Topcon GB-1000 First Article Receiver Testing
September 29, 2004
Victoria Andreatta

This document summarizes the changes requested by UNAVCO before the GB-1000 could be deemed fully acceptable as a campaign GPS system (acceptance of first article receivers). Please see the 'UNAVCO 2004 GPS Campaign System Testing' report located on the UNAVCO website at: http://www.unavco.org/facility/science_tech/dev_test/publications/publications.html for a complete description of the testing environment. The summary tables A.1 -A.3 contain all functionality tested and was meant as more of a summary for UNAVCO personnel.

Figure 1.0 - Graph of old power consumption, new value with heater on, and new power consumption value with heater off.

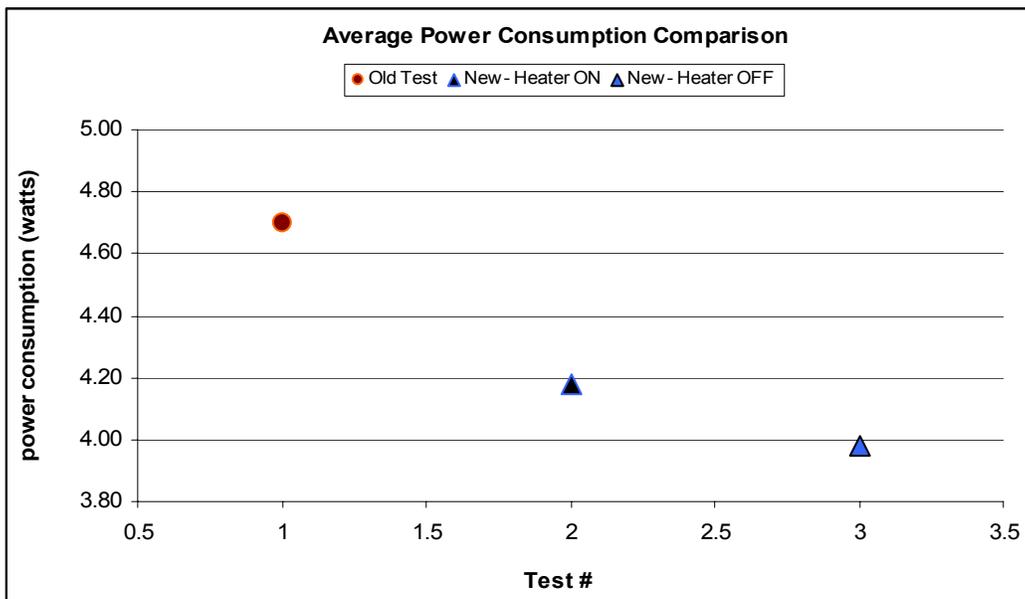
3. Item: Average power consumption of the GB-1000 was approximately 4.7 Watts with the old power boards. The first article systems were tested with the internal heaters on, and the internal heaters off.

Solution: The average power consumption with the internal heaters on is roughly 4.18 Watts, or 11.06 % less than the original value of 4.7 W. The average power consumption of the receiver with the internal heater off is 3.98 Watts, or 15.32 % less than the original value.
